### MEMORANDUM

**TITLE:** Review and Action on the Subdivision Permit & Plat for Jordan Pasture, located in a portion of Section 27 and the E1/2 E1/2 of Section 28, T.15 N., R.66 W., of the 6th P.M., Laramie County, WY.

**Jordan Pasture  
Subdivision  
Permit & Plat**

**PZ-18-00276**

## PRIVATE ROAD AND UTILITY EASEMENT DETAIL

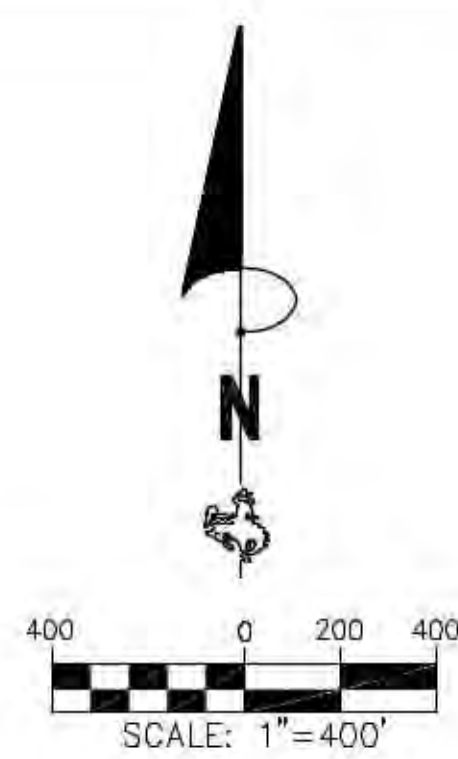
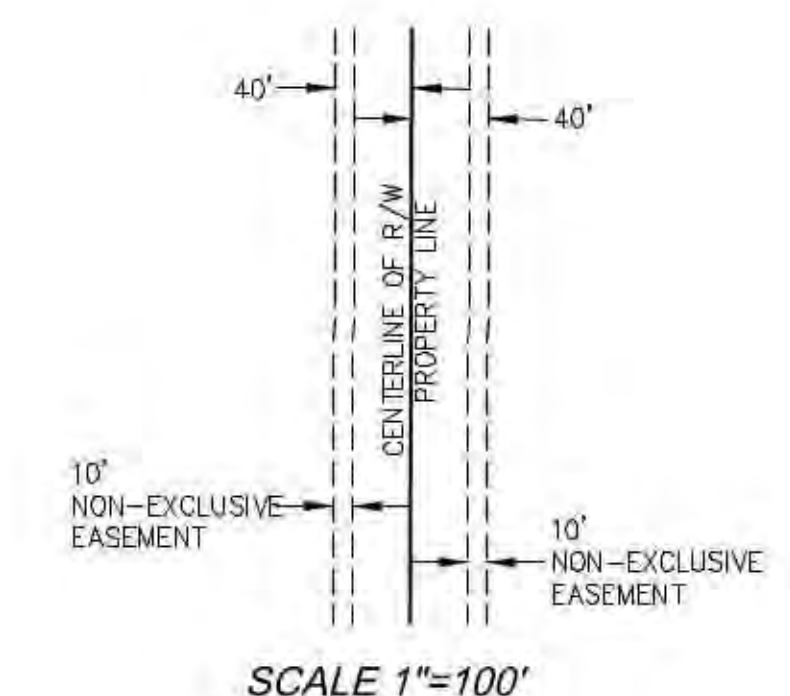
5. The last word in the 3rd paragraph of the DEDICATION is "LOTS", these are labeled as "Tracts" on both pages of the Plat.
6. In the drawing which is a part of the PRIVATE ROAD AND UTILITY EASEMENT DETAIL, the "10' NON-ECLUSIVE EASEMENT" on the left side should be "10' NON-EXCLUSIVE EASEMENT", on both sheets.

FINAL PLAT FOR JORDAN PASTURE

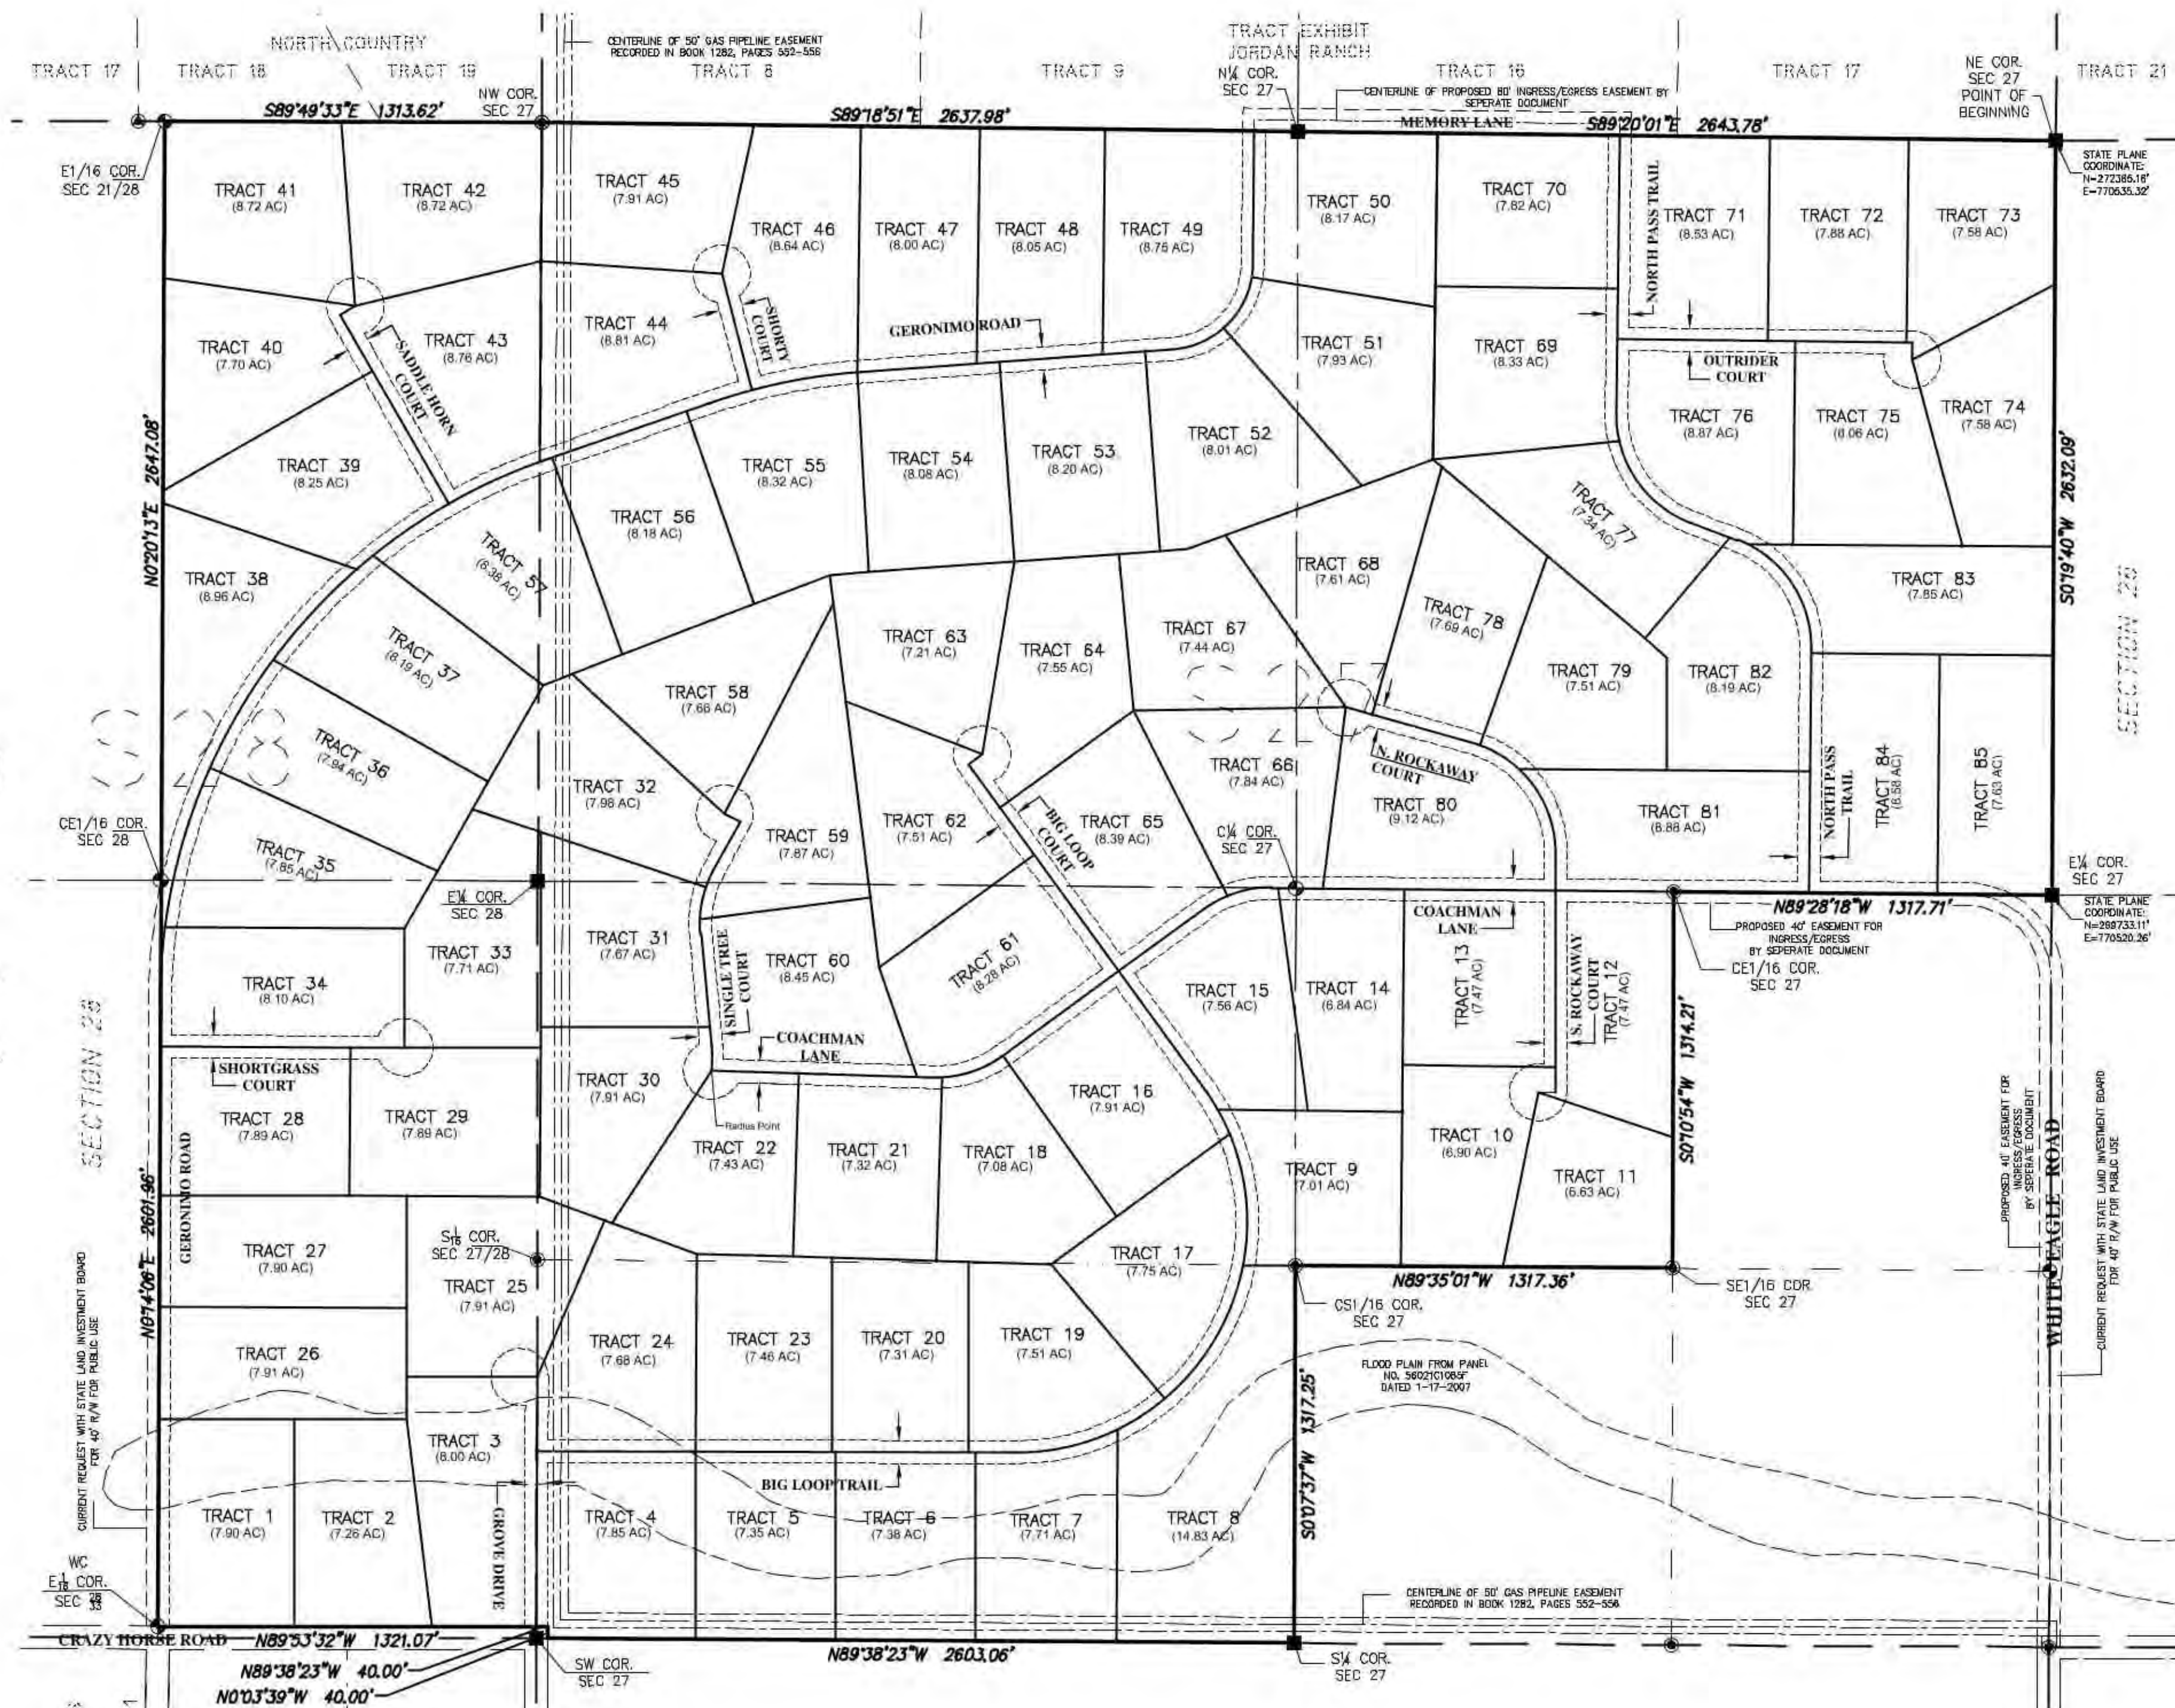
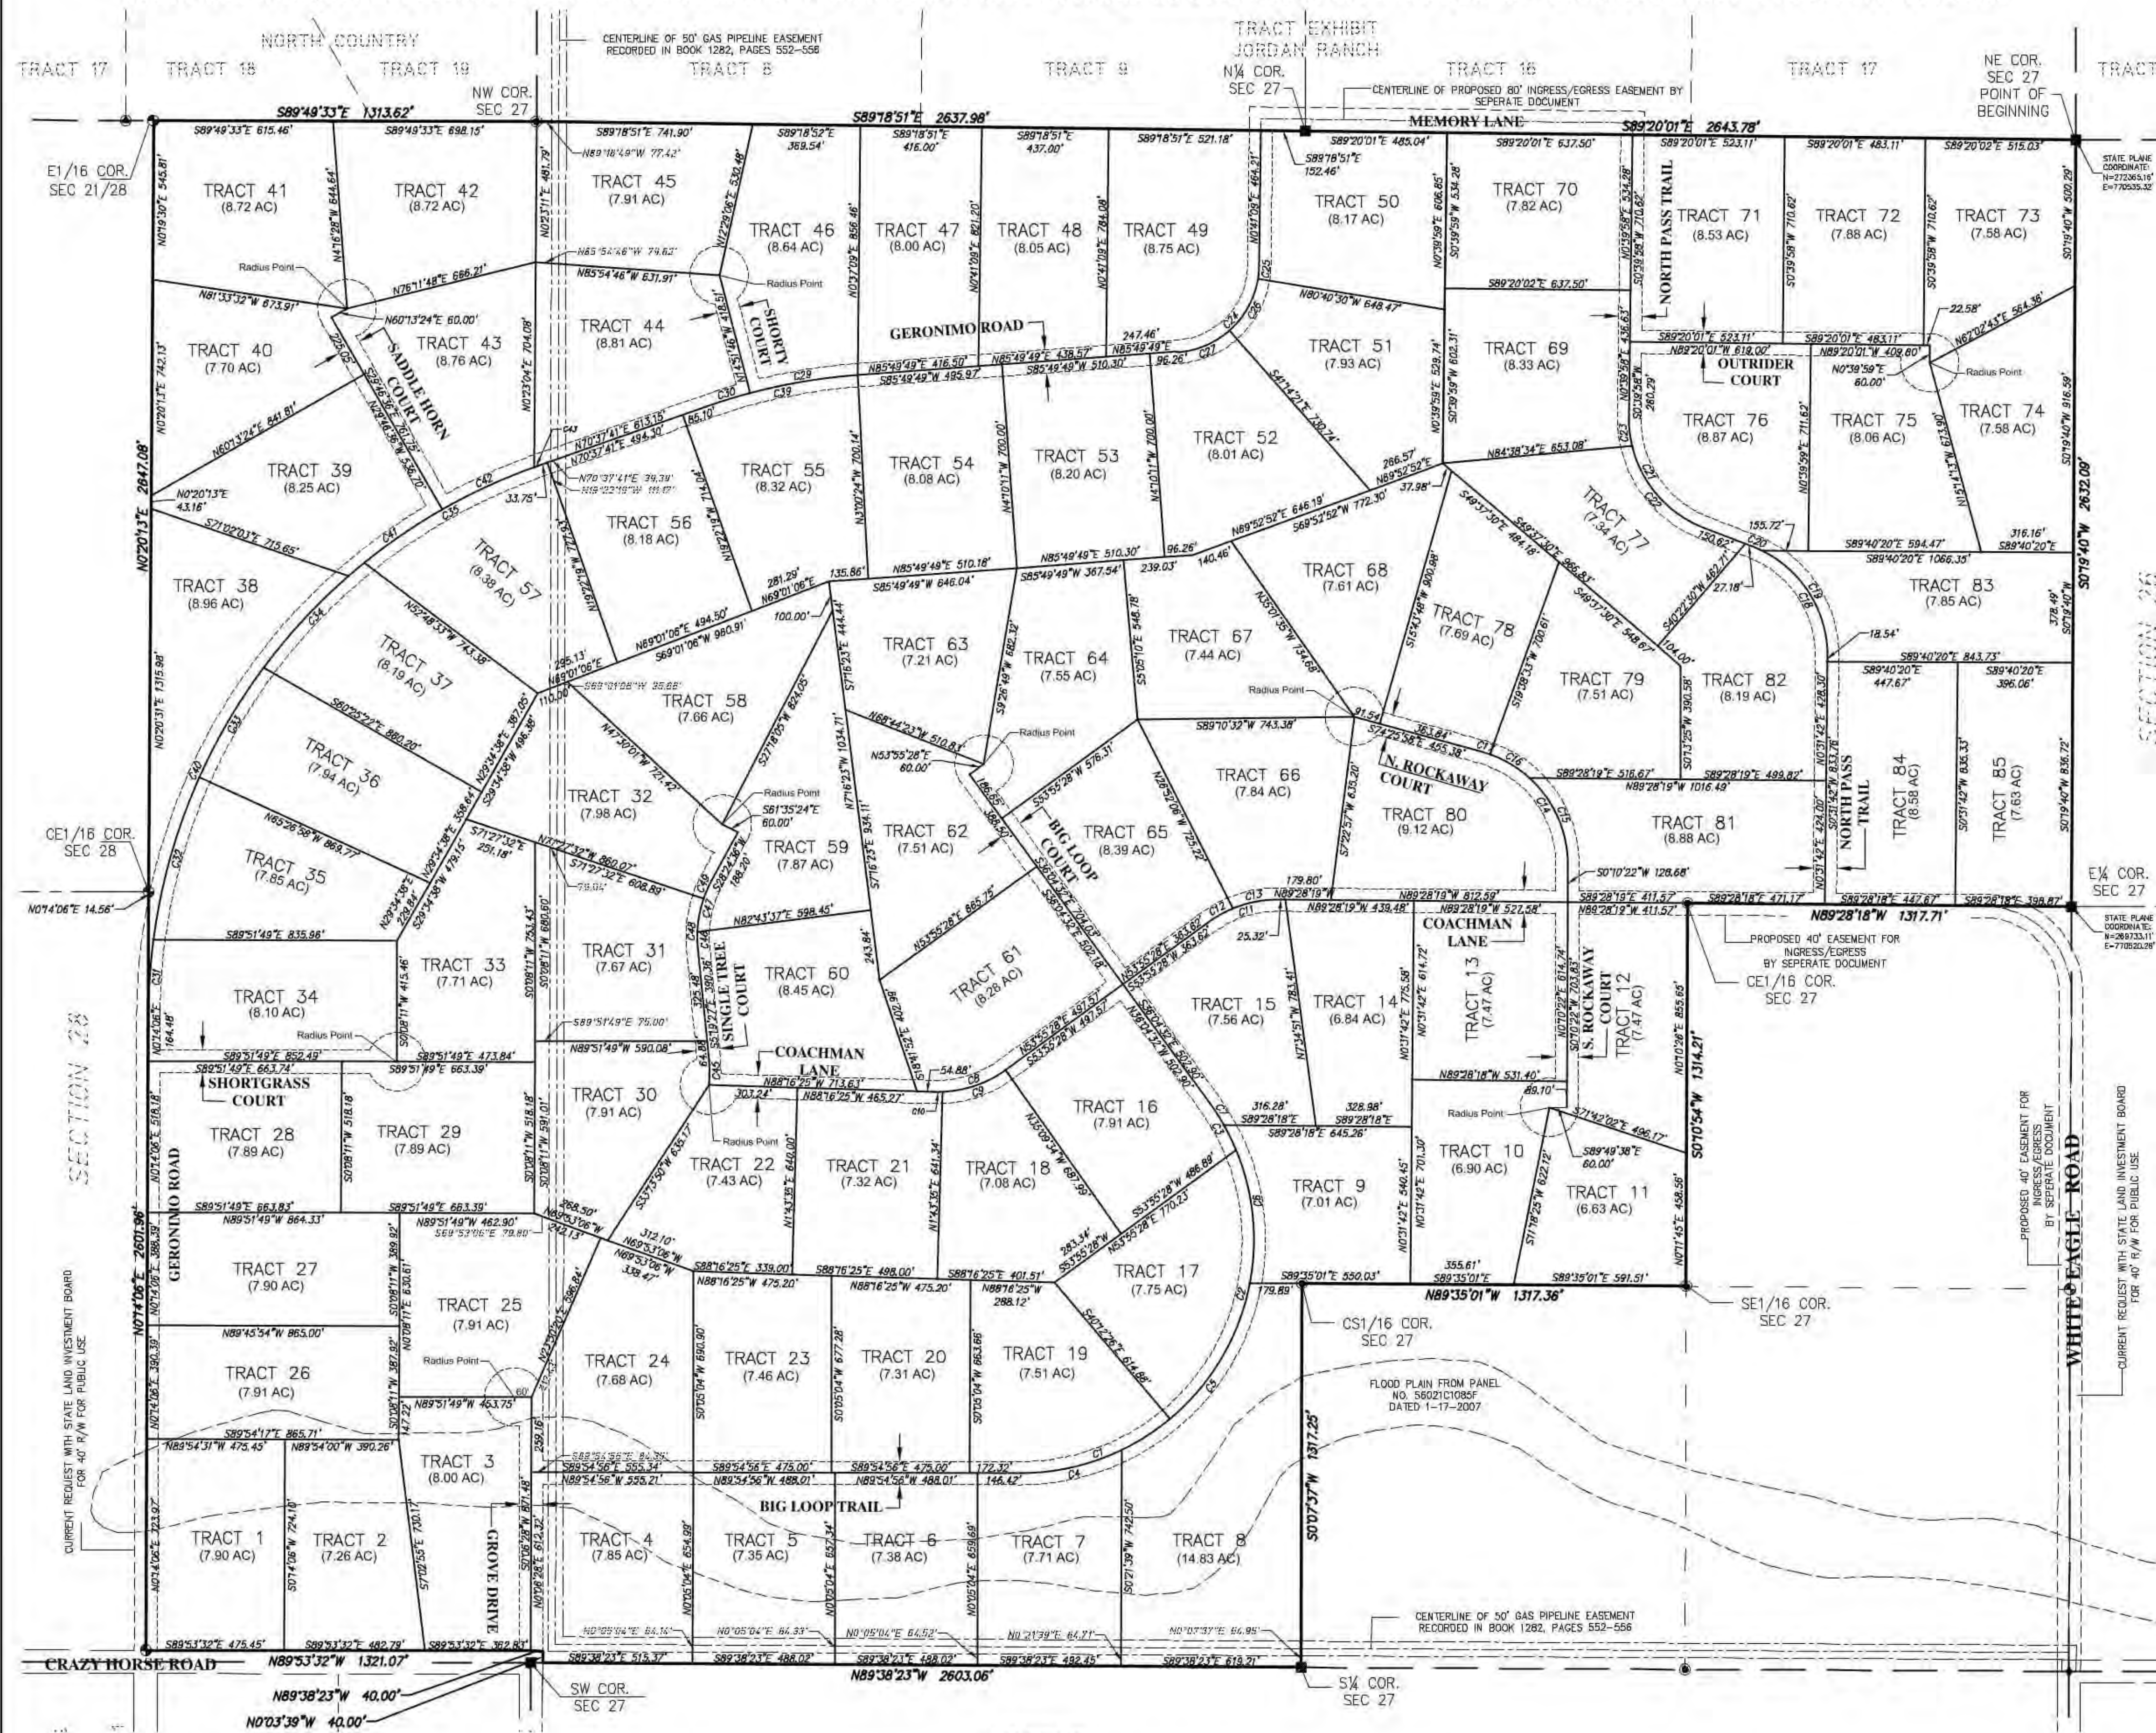
6. The Legend includes a "Buildable Area of Lot" but none are shown on the plat so this should be removed from the Legend.
7. The Traffic Study is adequate for this development. However, it doesn't say much about the off site roadway construction/improvements that will be required for Grove, White Eagle Road, etc. that don't currently exist.

1. There is no space provided and designated for the Laramie County Clerk's filing record.
2. The course at the beginning of the 3rd line of the main body of the legal description in the dedication states "N89°26'18"W", however that course on both pages of the Plat is identified as "N89°28'18"W".

3. At the beginning of the 12th line of the main body of the legal description in the dedication states "TO EAST LINE OF THE E1/2E1/2 OF SECTION 28", which should state "TO WEST LINE OF THE E1/2E1/2 OF SECTION 28".

4. The 3rd paragraph of the DEDICATION (the actual description of what is being dedicated to who and the approval of the owners) there is no description explaining or referencing the details of the dedication of the easements and rights of way, and that description needs to be included in this paragraph.

7. The 1/16 CORNER in the middle of west side of the subdivision is identified as "E 1/16 CORNER", but it should be identified as the "CE 1/16 CORNER", to be correct and consistent with the legal description on the Plat.
